# CPA schematic, BOM, and drawings update

HVS meeting on 2024-04-02 Glenn Horton-Smith

## HV connection drawing fixes needed

All drawing numbers refer to EDMS doc 2633164 v.1 file DFD\_CPA\_071123.pdf

## DFD-20-J100 rev 03 UPPER PANEL ASSEMBLY, TYPE "J": missing top miniboard on one side of CP, missing end boards

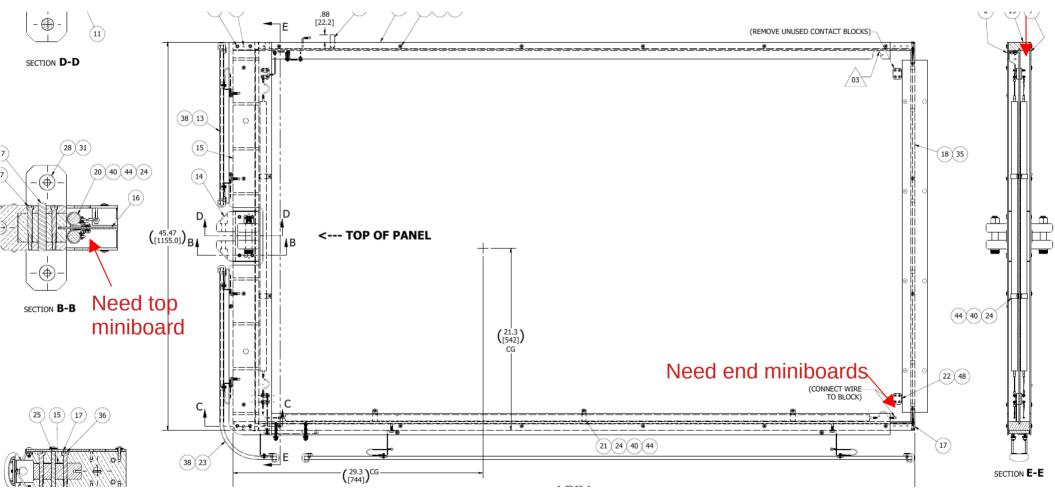
Question: Is it correct for G100 and J100 *both* to have their endwall profiles at the *bottom* of the page? It seems like we're looking at the *south* side of G and the *north* side of J. (Or the other way around.)
